15th July 2021
TPH/PL.01

THE POND HOUSE, AISLABY - NYM/2021/0274/LB

Further to your letter of 9th June 2021, I write in response to the comments received from NYMNPA on the above Application; I will address the items in the same order as raised in your letter.

DRAWING NO. TPH/P.105 REVISION A

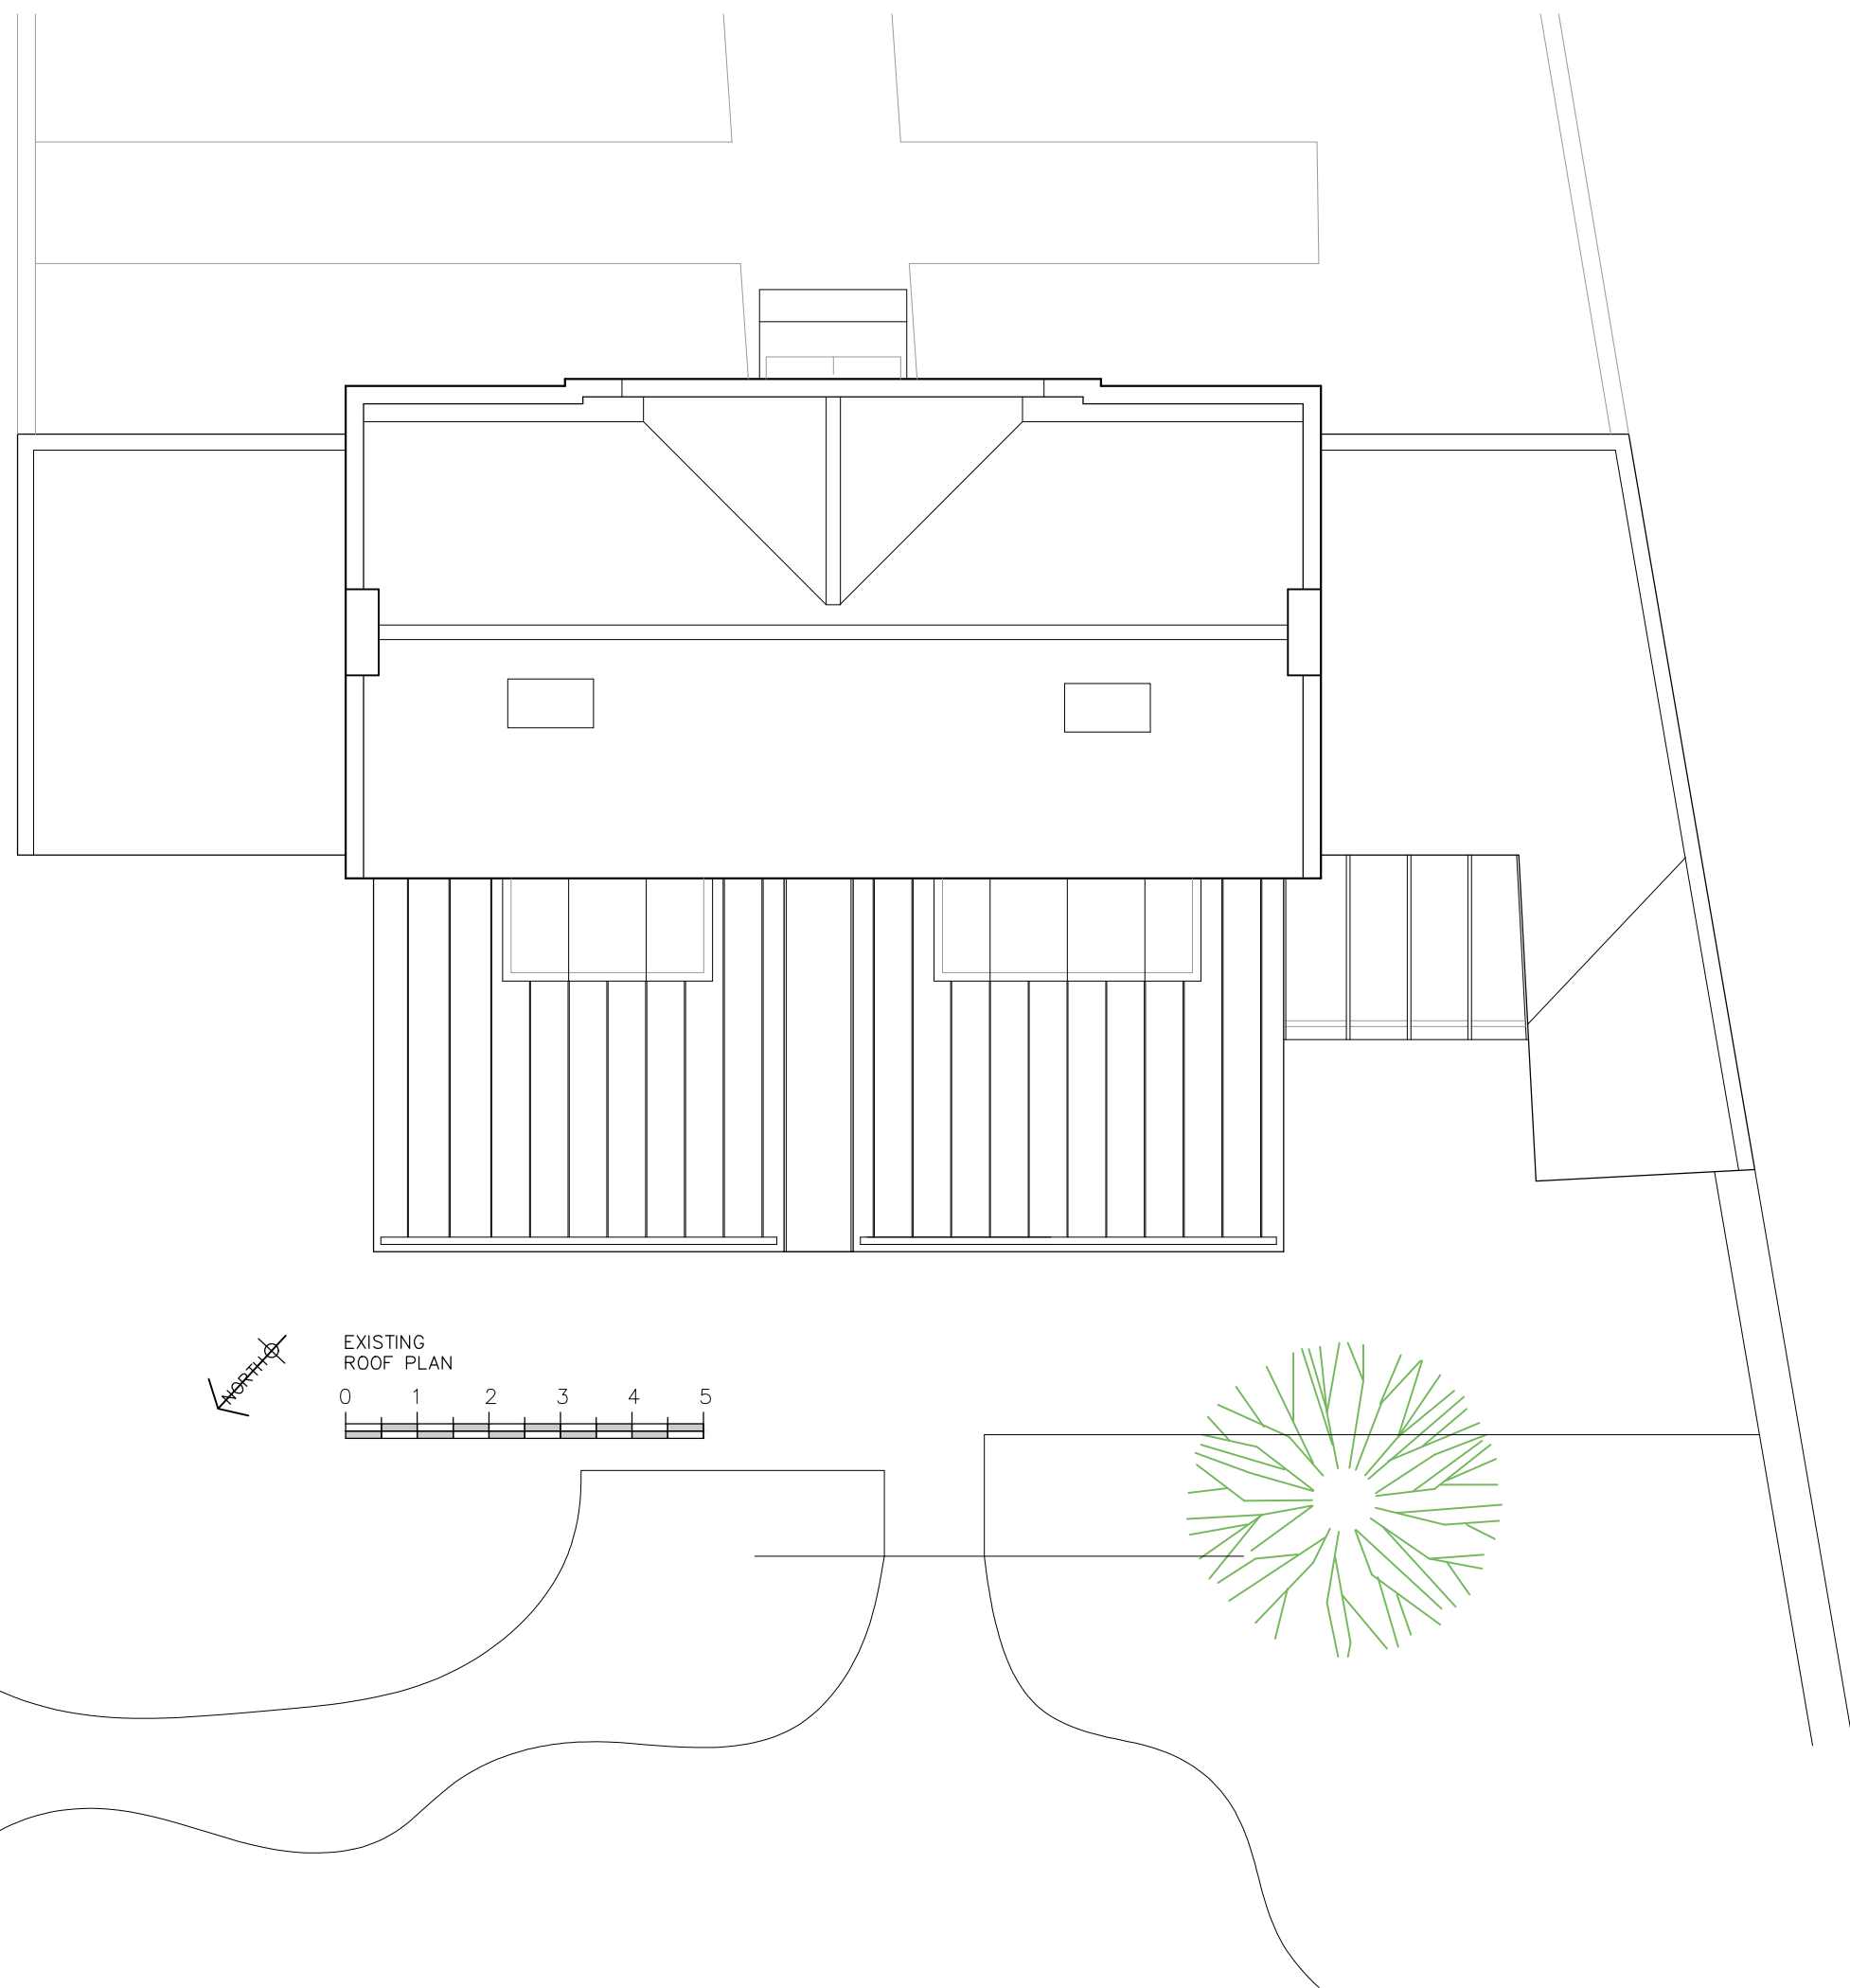
The comments regarding the extension proposed are acknowledged and understood.

- The main body of the extension has been realigned with the central portion of the house, symmetrically inset approximately 600mm from each side, so that the main three storey body of the house maintains the greater width.

- The depth of the extension has been reduced, such that the footprint no longer extends as far into the garden as the existing garage, and is now significantly narrower (approximately 2m) than that of the main house.

- To the west side, the extension still extends across the rear of the west wing, to provide access to the proposed Snug, as well as the Utility and WC (in the old outbuilding). While this entails overlap of the west wing, the proposed glazed façade and roof of this element will maintain a transparency and apparent separation. The Authority will recall the content of the Pre-Application advice, which suggested such overlap to the rear to be a preferred means of bringing the west wing into the house.
